KINGSTON FOSSIL PLANT - ANNUAL ASH POND DIKE STABILITY INSPECTION - FY 2008

Barry A. Kimsey, Manager  
COC Project Team  
Engineering Design Services  
LP 2G-C

**ANNUAL ASH POND DIKE  
STABILITY INSPECTION  
2008**

Fig. 1 Sluice Channels to Ash Pond

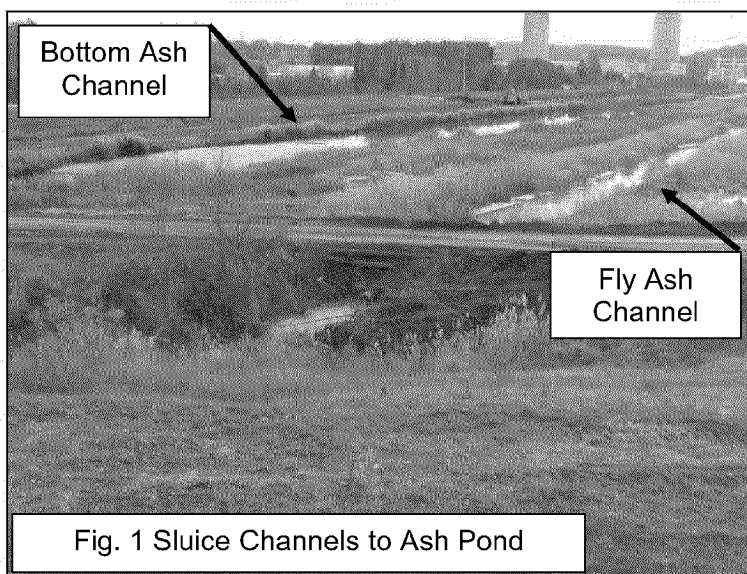
Fly ash is sluiced into an adjacent channel to the bottom ash channel where it flows into the main ash pond. The fly ash channel was cleared of vegetation last year. Both channels flow northeast into the active ash pond. See Figure 1 and drawing API 2008.

Fig. 2 Discharge to Stilling Pool

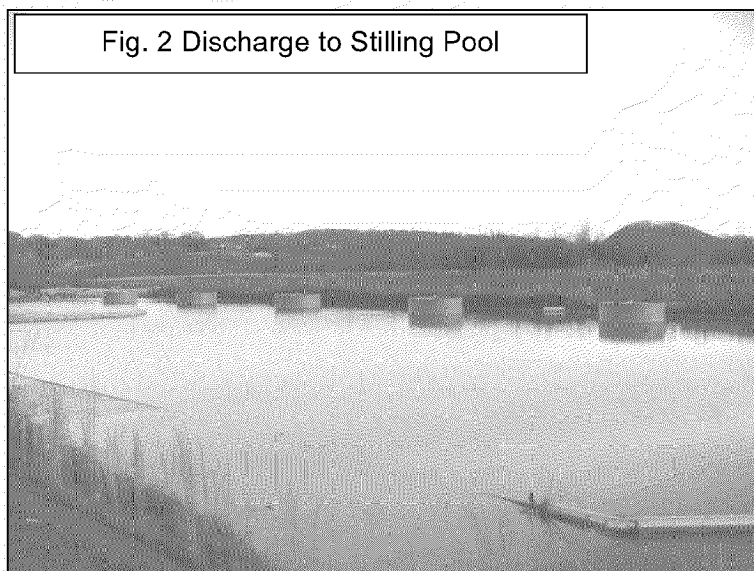
Sluice water flows from the active ash pond into the stilling pond through the five spillways constructed in 2005 (see Figure 2), as part of a project to allow more accurate accounting of free water volume. The old plant constructed spillway (Kennedy Weir) was taken out of operation at the same time. From the stilling pool, the water discharges into the plant intake channel via six standard spillways equipped with discharge diffusers constructed in November 2003. Many of these structures have vegetation and brush growing inside them, which needs to be removed.

- Remove vegetation growing inside spillway structures.
- Investigate the use of spraying to inhibit vegetation growth on the interior dikes of the stilling pond.

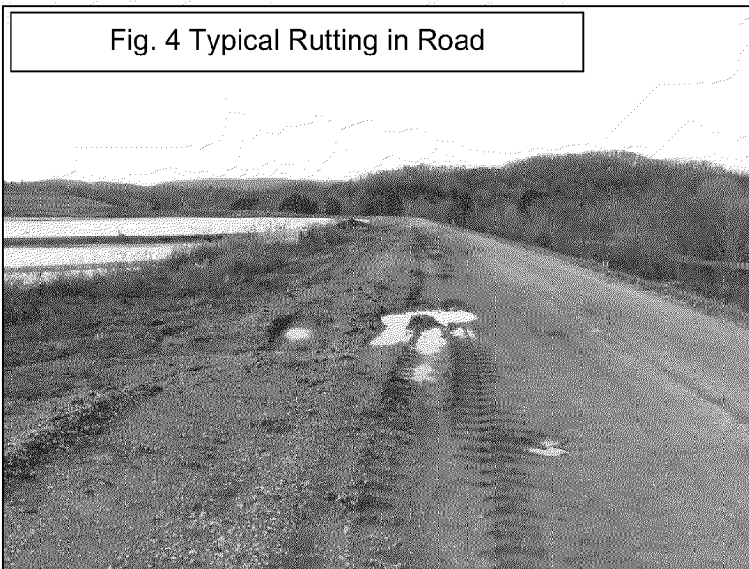
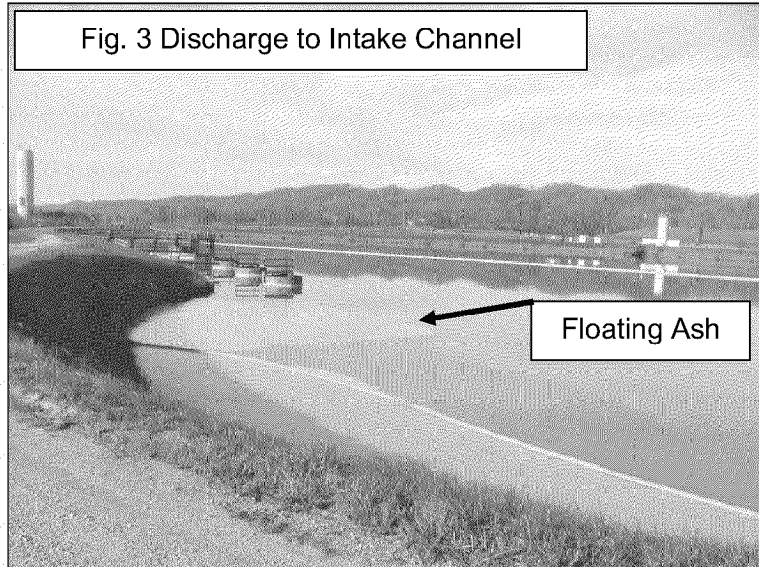
Large amounts of floating ash have been contained within floating skimmer booms (two inside both the active ash pond and the stilling pool). This ash should be removed in order to prevent an accidental release. Some of this ash has breached the booms and is near the discharge structures. See Figure 3. The seeps along the toe of Dike C and below the toe of the dike along the intake channel, known since the early 1980s were not visible during this inspection.

Some of the dike roads exhibit areas of rutting, see Figure 4. This photo is typical of the conditions of the roads, although it does not appear to be a significant problem

- Remove ash floating on the surface of the ash and stilling ponds.
- Repair rutting in the access and dike roadways. Fill with bottom ash and regrade as required to promote drainage.

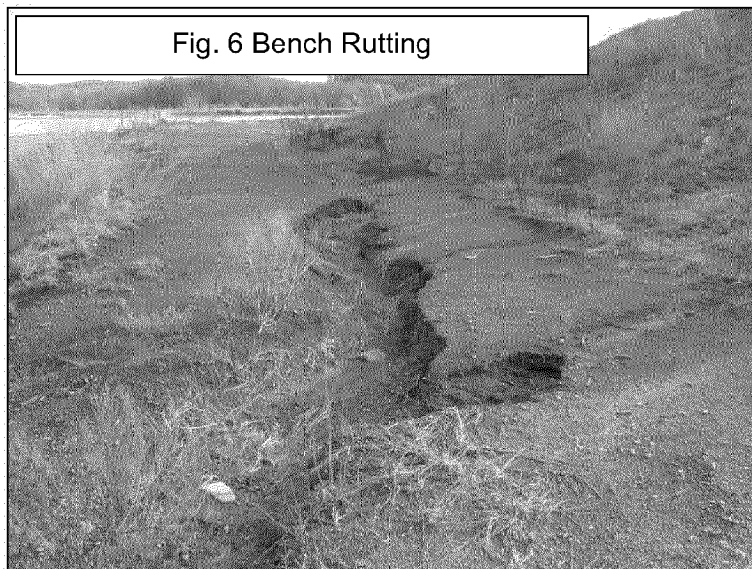
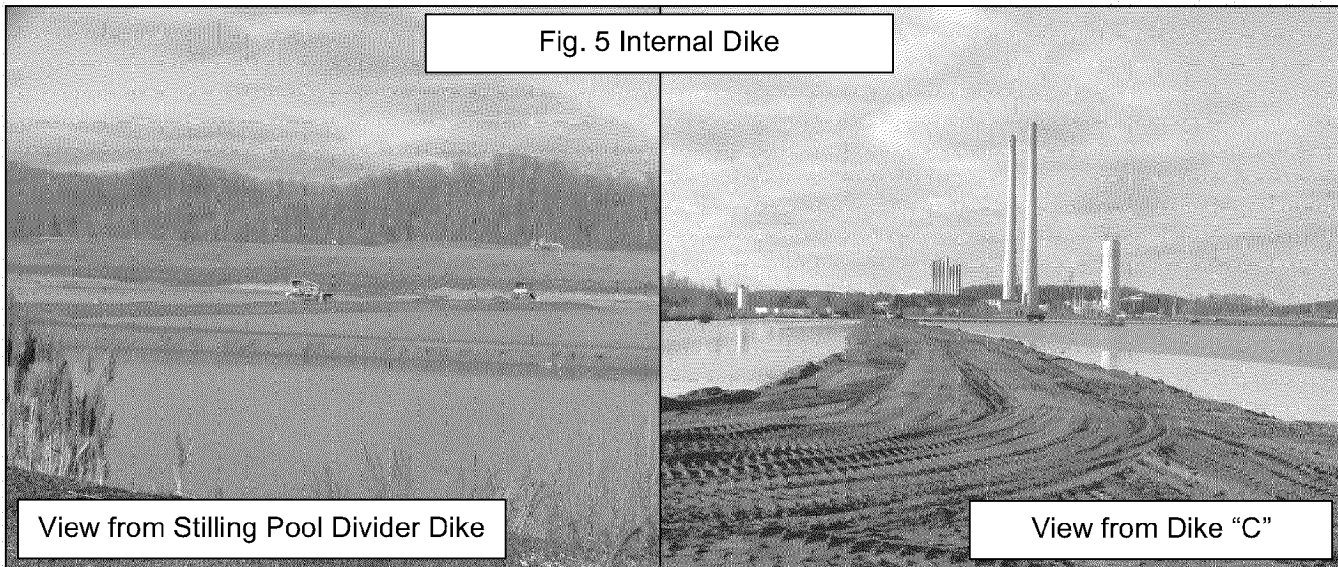
Construction of an internal divider dike inside the active ash disposal area is currently underway. The divider dikes will be constructed to build a base of fly ash for a dredge cell expansion, which will eventually cover approximately half of the existing main ash pond. See Figure 5.

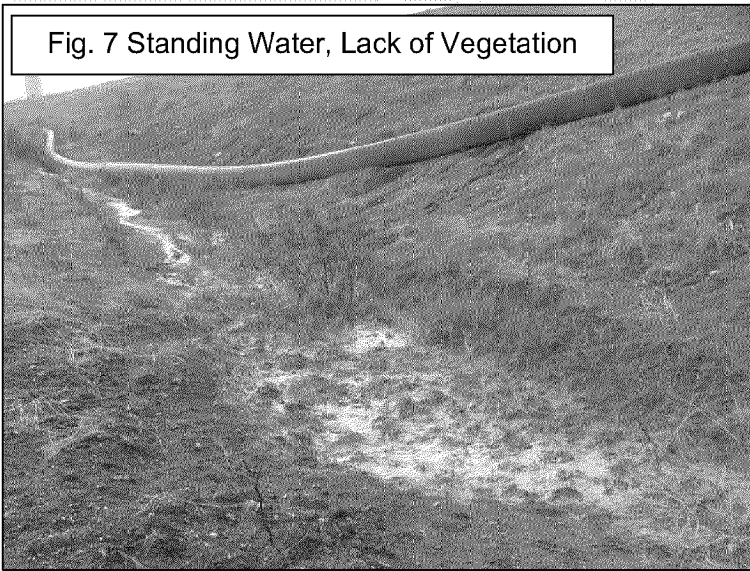
interim cell to the main ash pond. Water flow into the interim cell is essential for dust control. The divider dike between this cell and the active pond appeared to be in stable condition with some bench rutting and poor vegetation. There was one section of standing water approximately 100 feet in length. As much as practical, these areas should be graded so they will drain, even if slowly. Wheel ruts that hold water should be filled with bottom ash and covered with stone if they are in a road. See Figures 6 and 7 (next page).

Fig. 9 Looking NE along Bench #1

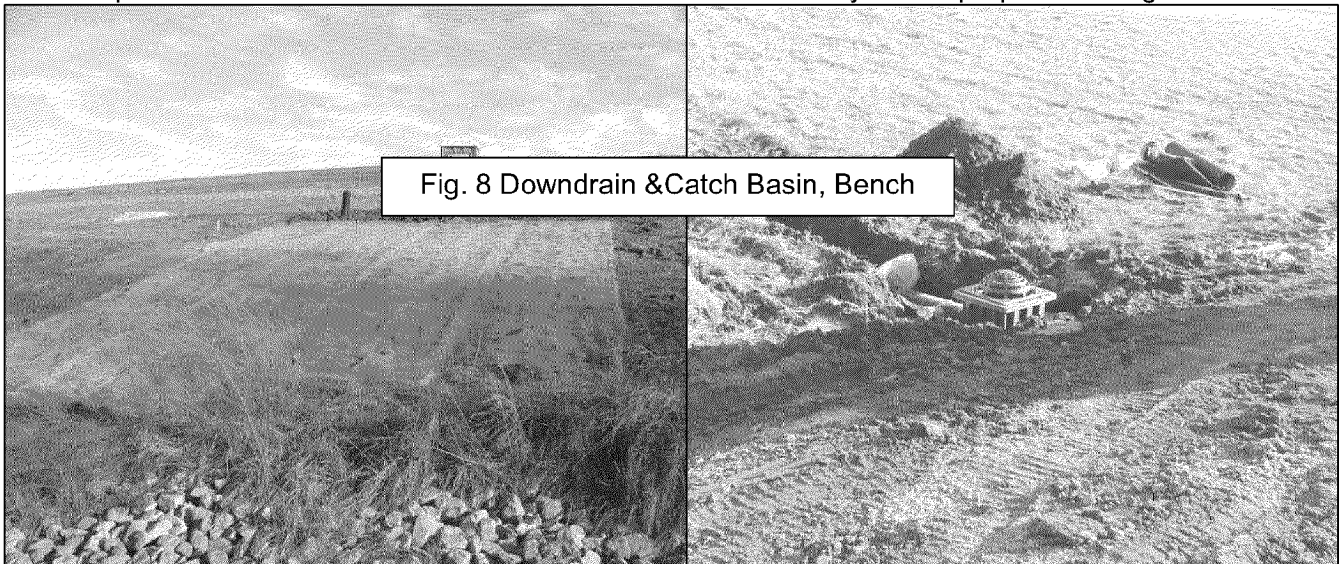
Since last year's inspection, ash was dredged into Cells 1, 2, and 3 to such levels that the divider dikes for Cell 3 were buried and now there are only two large cells (1 and 2). Dredging was stopped in mid-November 2007 based on recommendations from EDS and Geosyntec Consultants, Inc. This preventative measure was taken to reduce water levels in the dredge cell through the winter months in an attempt to avoid another blow out. EDS collaborated with Geosyntec to prepare a design to address

the poor bench drainage. The lower benches will be re-graded to provide positive drainage to a series of catch basins which will divert the water collected to the lower drainage ditch. Construction is currently underway to install surface drainage repairs, (See Figure 8, Figure 9 (next page), and Drawings 10WXXX-1 through -10 for details). In addition to these repairs, outlets are being installed on the old dewatering wells to allow personnel to relieve some of the water in these wells. The water drained will flow to the riprap channel along Swan Pond Road.

Fig. 10 Trees near Discharge to Pond

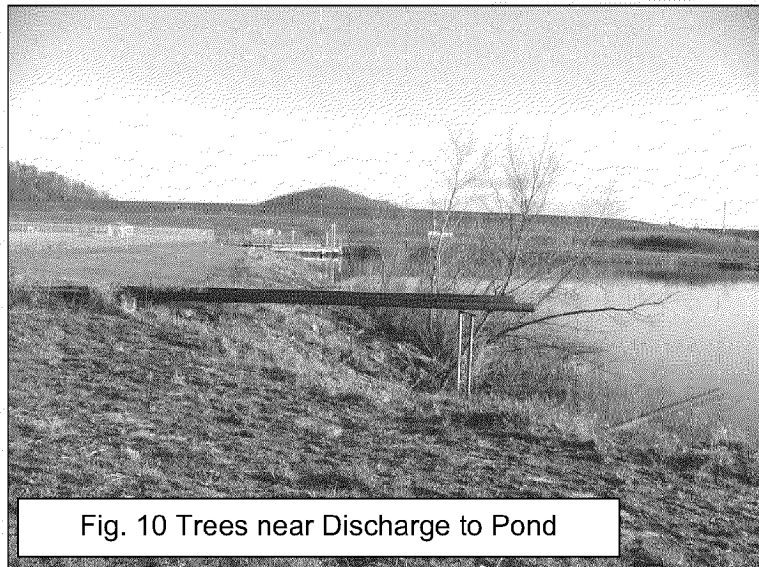
The chemical treatment ponds (iron and copper) are located southwest of the active ash pond. Both ponds were excavated and have no exterior slopes. The internal dike slopes are covered with riprap. These slopes were in good condition with a few trees present. See Figure 10. Sediment in the ponds was tested in FY 2004 and found to be non-hazardous. It appeared that some maintenance had been recently performed at one of the pond platforms. Old gaskets were on the ground and there was a new pipe flange and hardware. The platform at the smaller pond was missing a pump.

- Remove trees from the slopes of the dikes. Mowing at least twice a year is recommended to control the size of the trees. Preventing the trees from getting larger than 1" in diameter at the ground is preferred. Any trees larger than 3" in diameter at the base must be pulled from the dikes, roots and all. Repair and reseed the damaged area.

Fig. 12 Engineered Wetlands

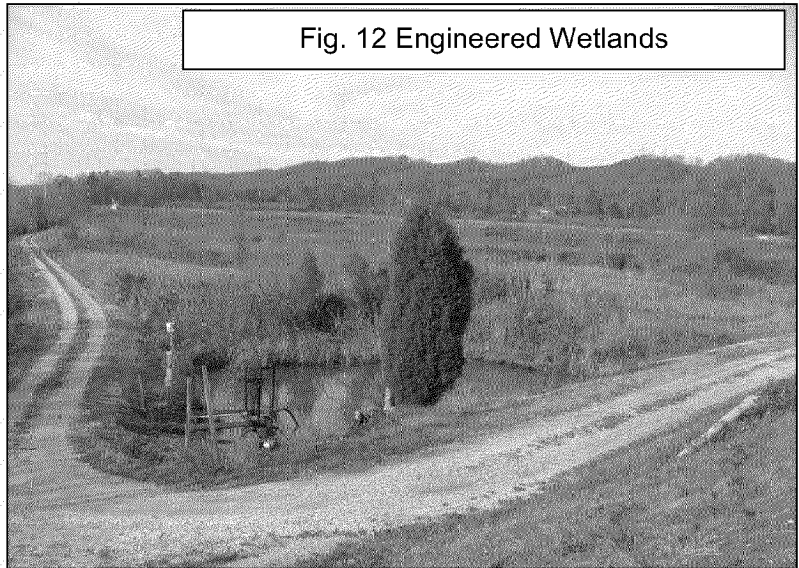
The engineered wetlands along the southwest dike receive seepage that collects in the anoxic limestone drain below the bottom ash trench. The wetland appeared to be functioning, but the discharge is still pumped via two pumps to the ash pond, see Figure 12.

The water levels in the pump structures were at different levels at the time of inspection. There were several trees varying in size growing on the interior dikes of the ponds.
